## Reviewer 1

This preprint introduces a geolocation method, occasionally referred to as a tool, designed for application to EarthCARE. This method draws upon the experience gained from the observations and methods developed for CloudSat and CALIPSO. The geolocation method previously applied to CloudSat was based on a Digital Terrain Model (DTM) that was coarser than the ASTER DEM/WBD products used in this preprint. When applied to the CloudSat/CALIPSO datasets, the proposed method demonstrates strong performance, and the quantification of the pointing error is more precise. Examples of the application for EarthCARE geolocation are provided, though a more stringent performance indication likely requires actual data. Nevertheless, optimal areas for applying the geolocation methods within EarthCARE are defined. The manuscript is well-written and easy to understand, though some points require clarification.

Figure 1. [...] Panel (c) shows the original DEM (grey dashed line), the simulated DEM using the satellite's footprint (black line), the coastline location (red dashed line) and a simulated water land navigation flag (blue line). [...]

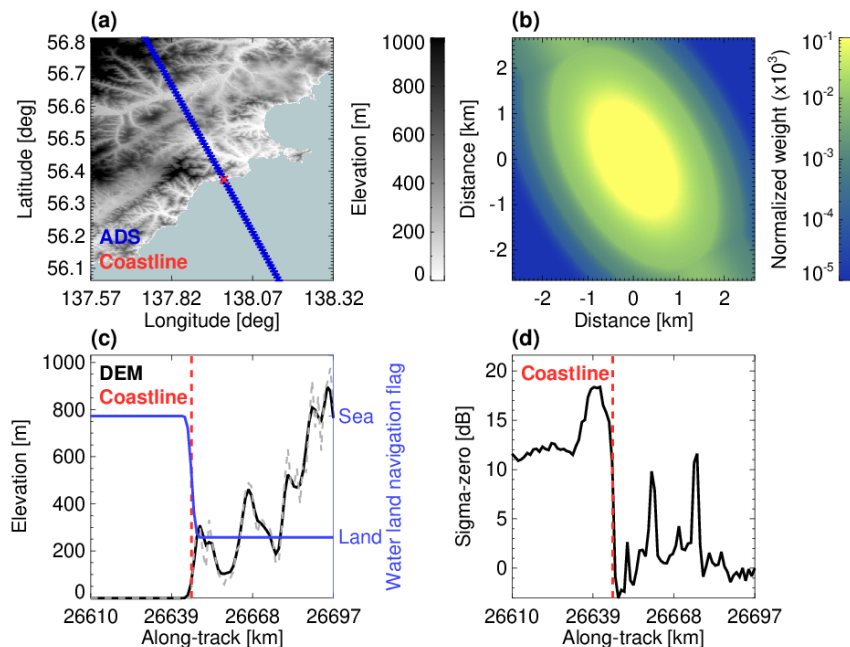
1. Fig. 1: It would be beneficial to include a comparison with the Digital Elevation Model (without convolution) in Fig. 1c.

The original DEM (without convolution) has been added to Fig 1c and the legend has been updated accordingly:
